NEWMAR CORPORATION WARRANTY DEPARTMENT

| TECHNICAL SERVICE BULLETIN | | | | | | | |
| 8/31/98 | 1995-1998 | ALL | 160 | | | | |

WATER HEATERS - MODELS LISTED
"ORIFICE" INFORMATION

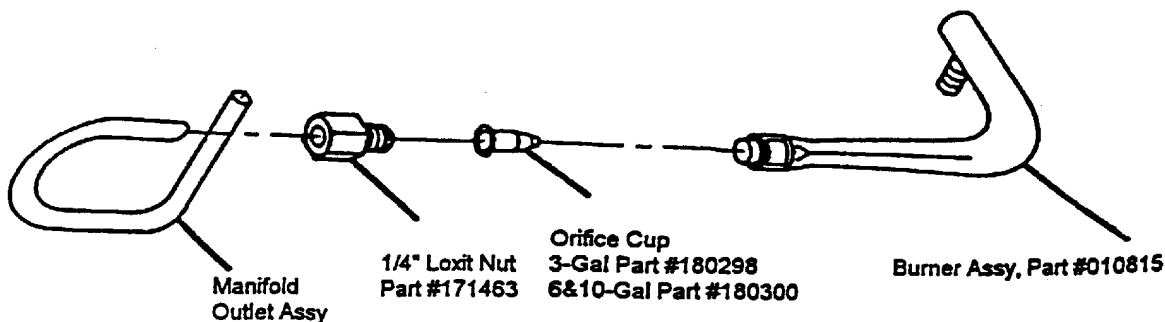
Orifice cups, which regulate the gas flow into the water heater, are held in place by securing the manifold loxit nut into the burner. If you remove the burner for any reason, be certain that orifice cup is in it's proper position when the burner is reinstalled. The diagram below shows the correct assembly and part numbers. Operating the water heater with the orifice missing can result in serious damage.

This design applies only to the following models:

SW3 (3 gallon) beginning serial number 953602451, ending 974400950
SW6 (6 gallon) beginning serial number 953401118, ending 974400950
SW10 (10 gallon) beginning serial number 953601021, ending 974400950
